GNRO-2007/00061

SUBJECT: Supplement to Amendment Request
Changes to the Condensate Storage Tank Level-Low Setpoints
Grand Gulf Nuclear Station, Unit 1 (GGNS)
Docket No. 50-416
License No. NPF-29

**Response to Request for Additional Information Related to
Revising the Condensate Storage Tank Level-Low Setpoints**

Sketch of HPCS/RCIC CST Suction Piping Diagram

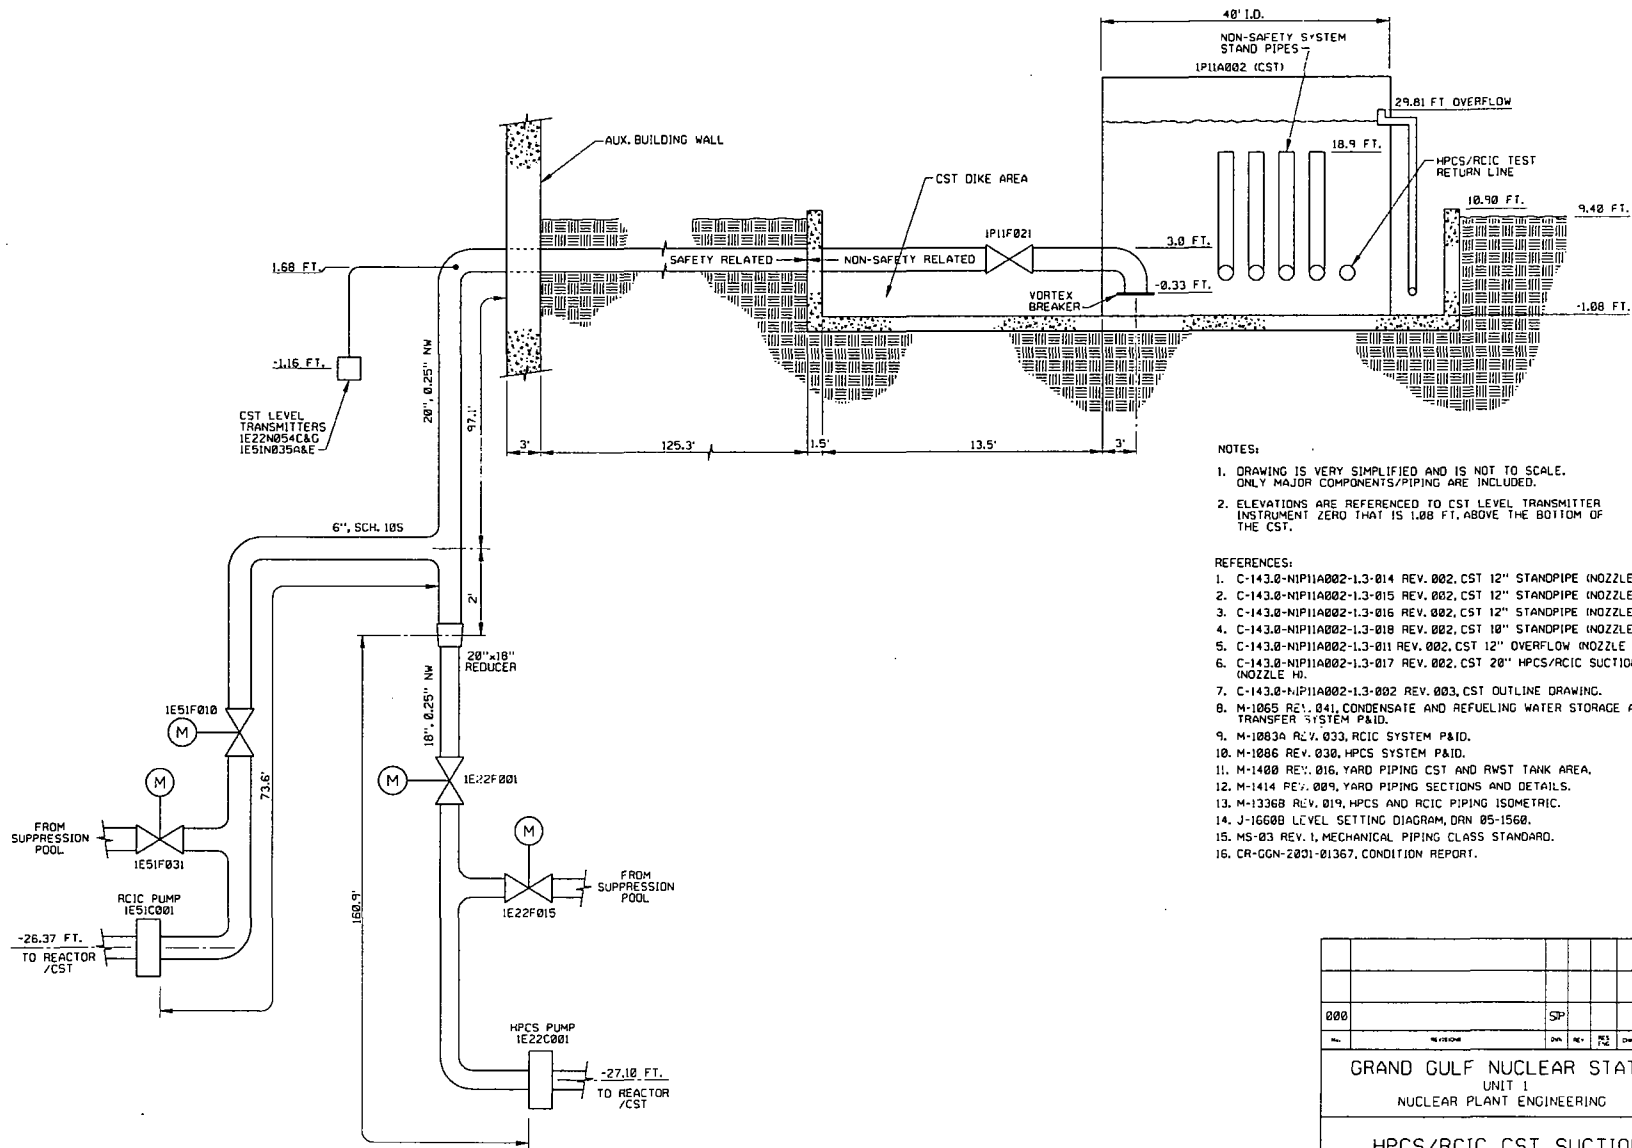
1. Please provide the physical layout diagrams of the condensate storage tank (CST) and the non-safety related HPCS/RCIC suction piping associated with the new calculated values. Also, provide the calculations used to determine the new values.

A simplified diagram of the piping arrangement labeled "HPCS/RCIC CST SUCTION PIPING DIAGRAM" is provided as Attachment 2. Copies of the setpoint calculations JC-Q1E22-N654-1, Rev 3 (Attachment 3) and JC-Q1E51-N635-1, Rev 1 (Attachment 4) are also included.
